13 December 1955

SUBJECT : Specification of 9 $\frac{1}{2}$ " Continuous Printer Printing Drum.

Attachment:
Sketch a/s in para 2.

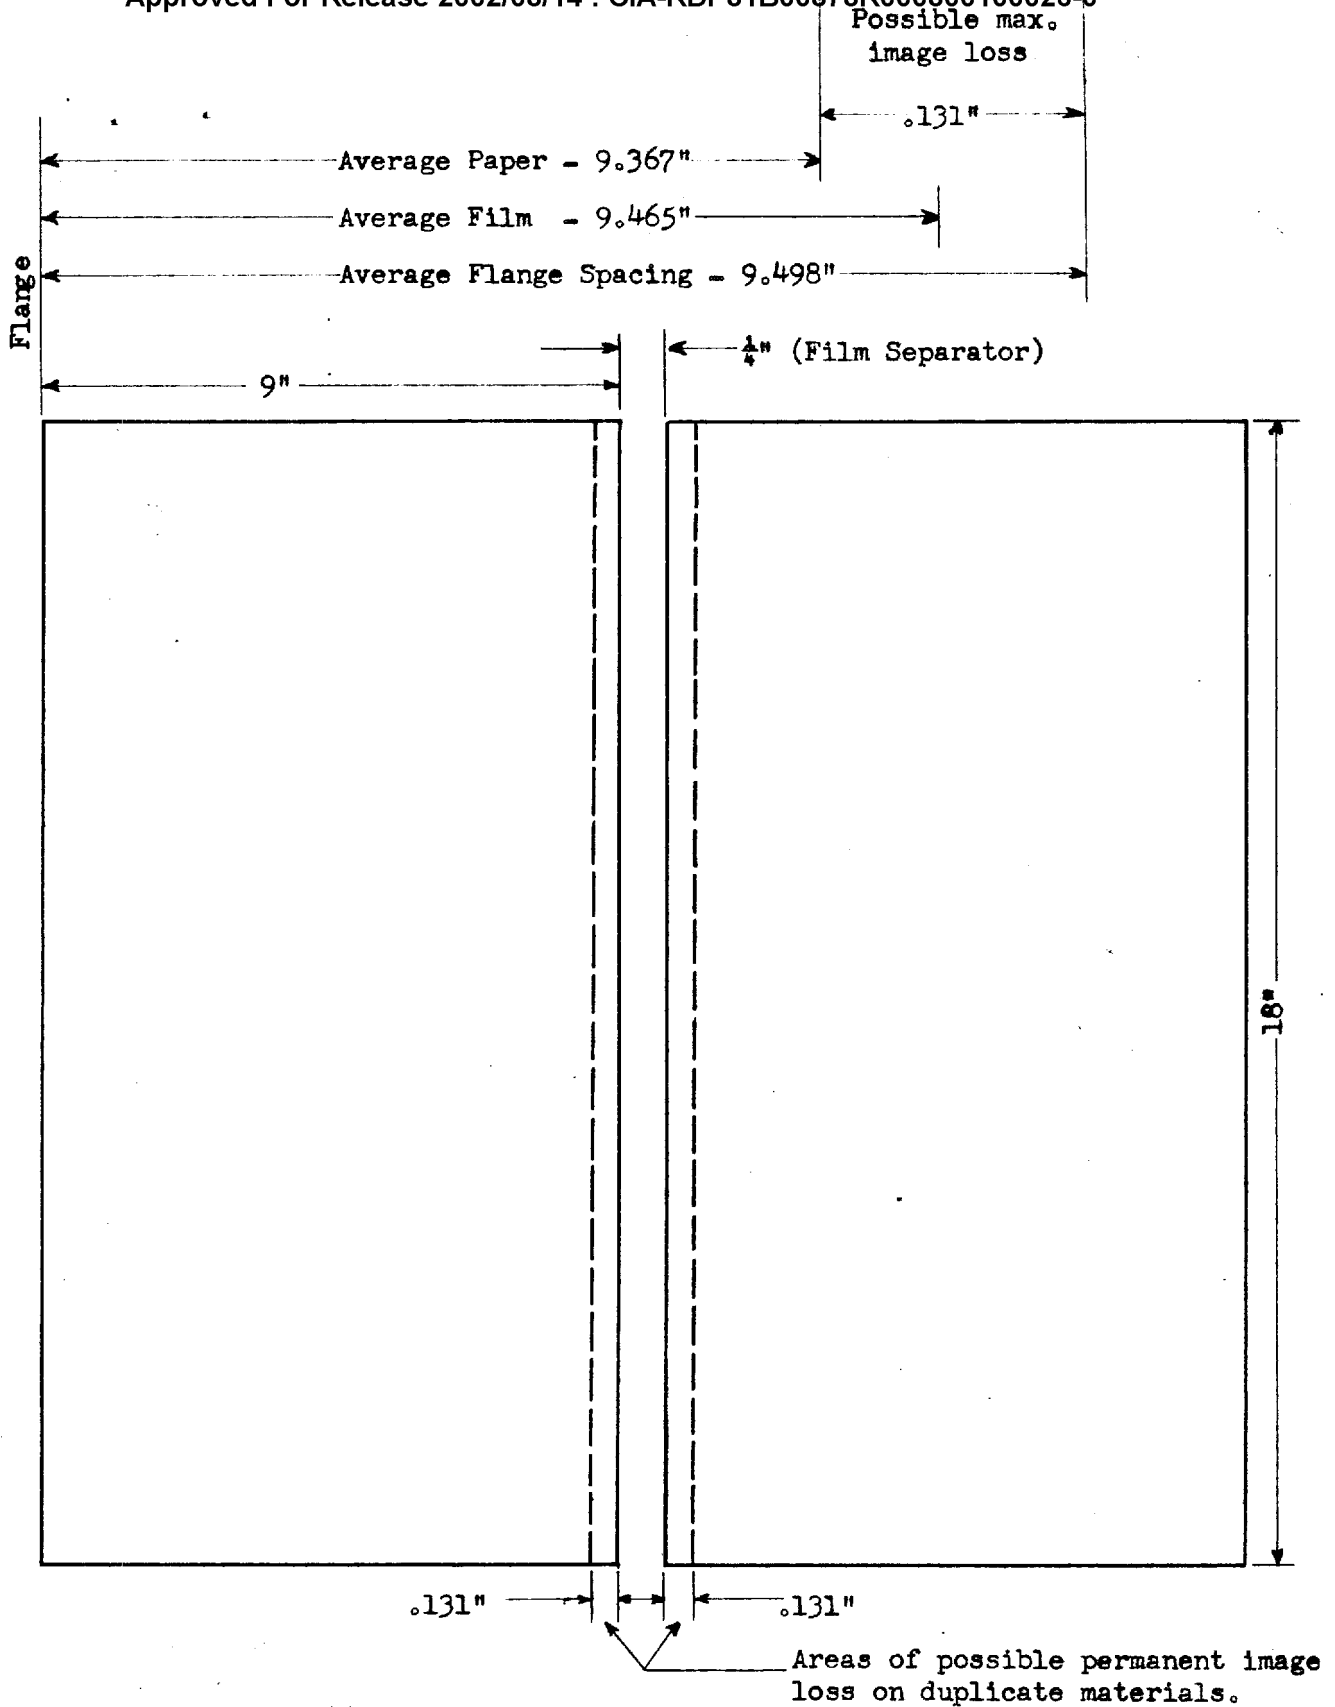
2. The earlier discussions were initiated to determine the feasibility of providing a protective edge on duplicate material from the B and C cameras. This edge is still desirable but the dimensions provided by indicate a possible loss of image area in the preparation of duplicate material. The attached sketch indicates the possible loss of image which may occur. The loss of any image area is felt to be very serious and should be prevented if at all possible.

3. It is recommended that Eastman Kodak be contacted to determine the feasibility of altering the printing equipment so as to insure the retention of all image area of the negatives from the B and C configurations.

$$\left(\frac{.131}{12}\right) \times 2 \times \frac{70,000}{(36/12)} = 509' = \text{Possible loss of coverage in duplicate materials.}$$
